1937d

ALASKA DEPARTMENT OF FISH AND GAME
SUSITNA HYDRO AQUATIC STUDIES

REPORT NO. 3 PART II, Chapter 8

EVALUATIONS OF SALMON-SPAWNING HABITAT IN SELECTED TRIBUTARY-MOUTH
HABITATS OF THE MIDDLE SUSITNA RIVER

Figure 8-11 Habitat and clearwater plume area (expressed as surface water area) at the Lane Creek tributary mouth study area (RM 113.6) versus Susitna River discharge (USGS gaging station, 15292000), 1983.

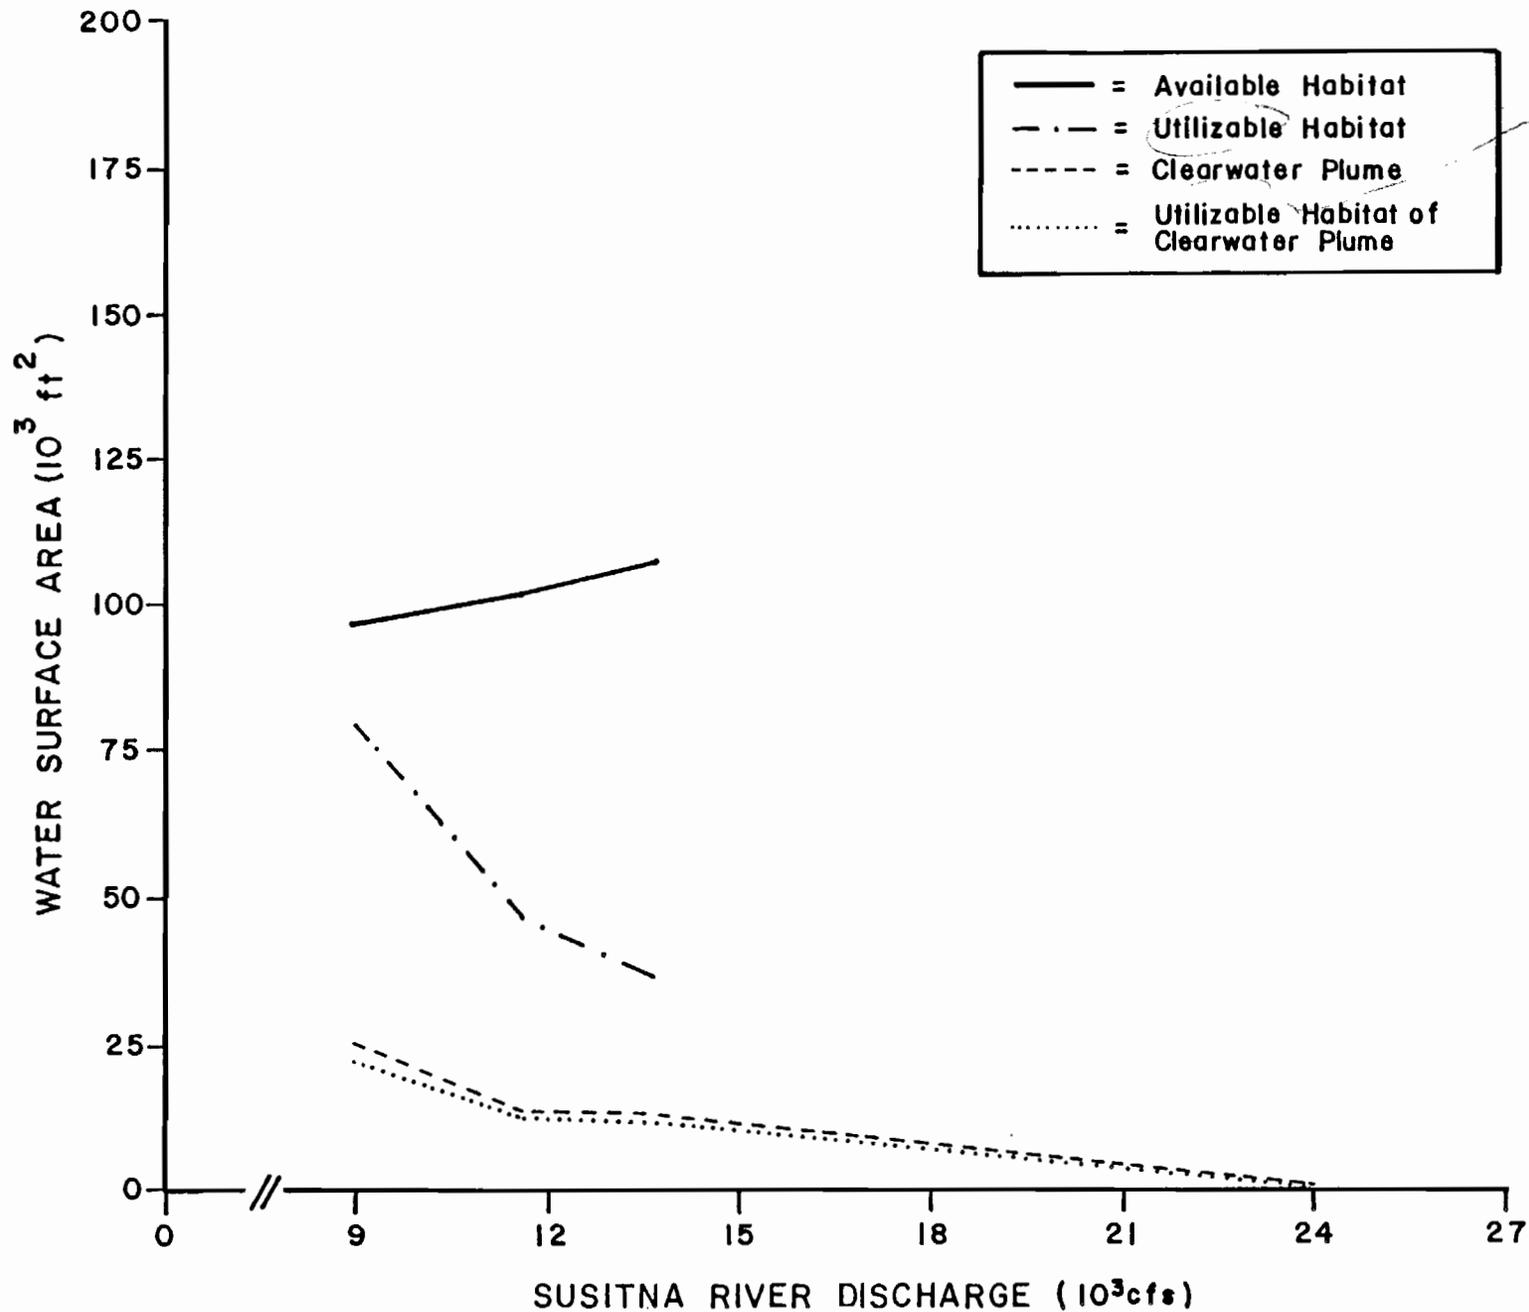
utilized
or usable?
not consistent
with
glossary

Figure 8-30 Surface water versus intragravel water temperatures observed at active chum salmon redds at the Fourth of July Creek tributary mouth study area, 1983.

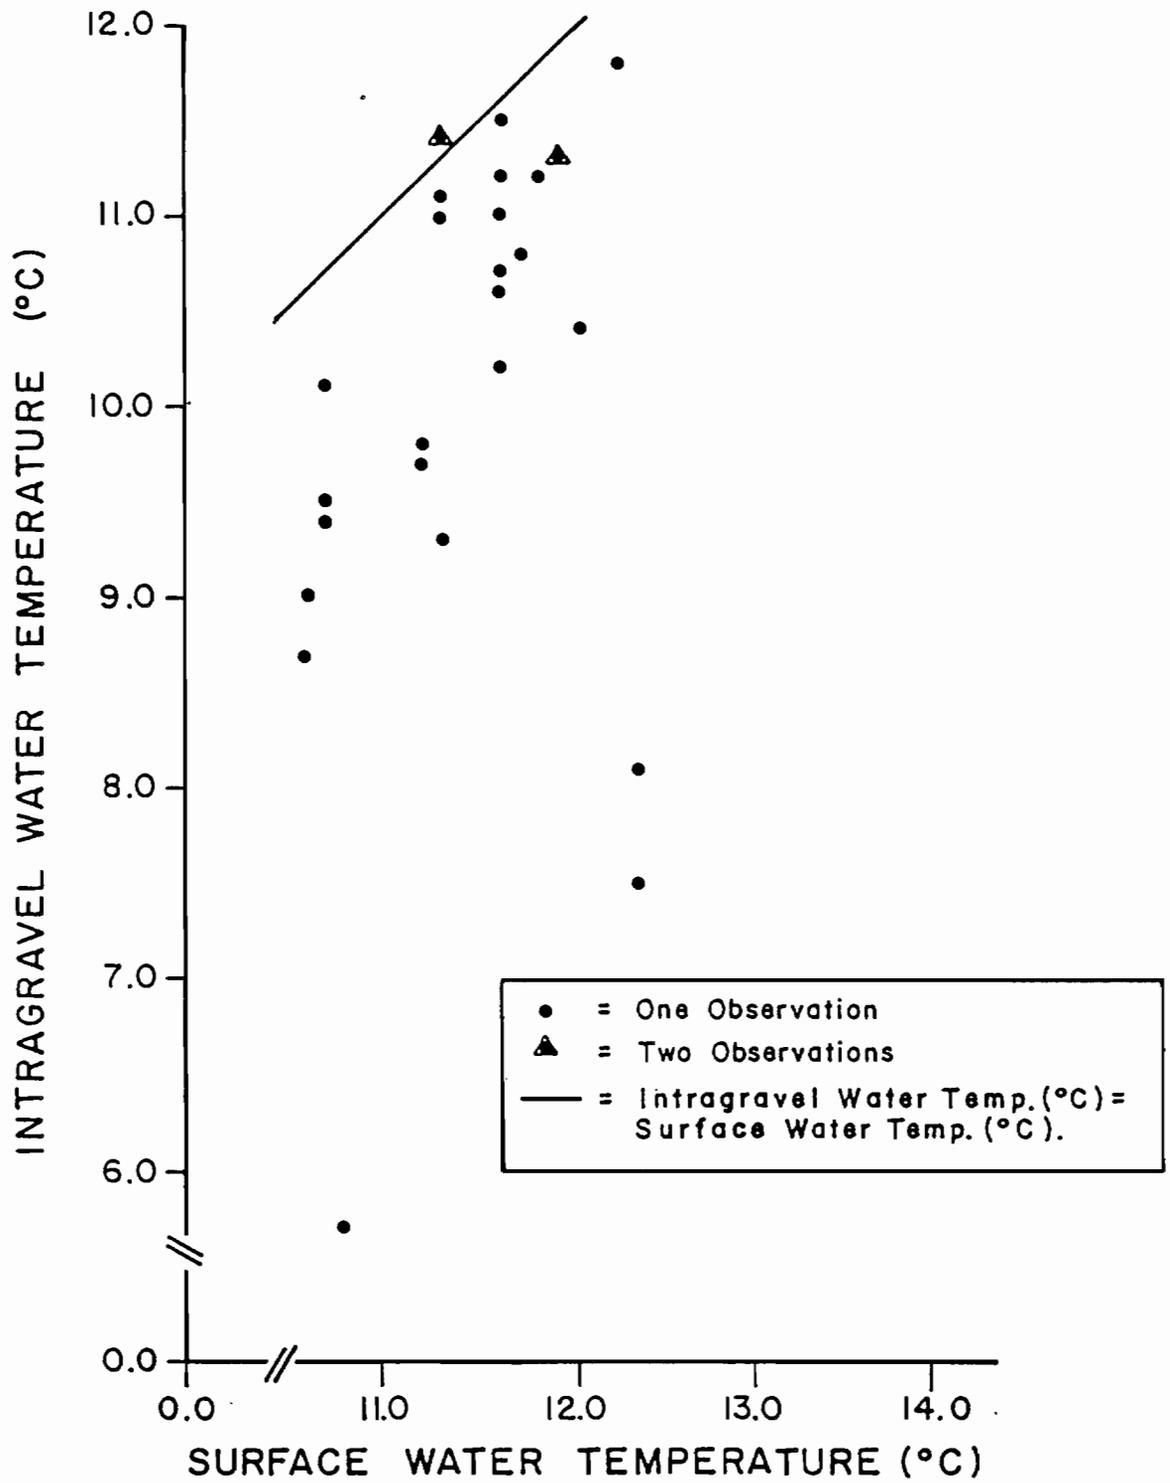
How?
Do they
differ
w/ day
warmer
?
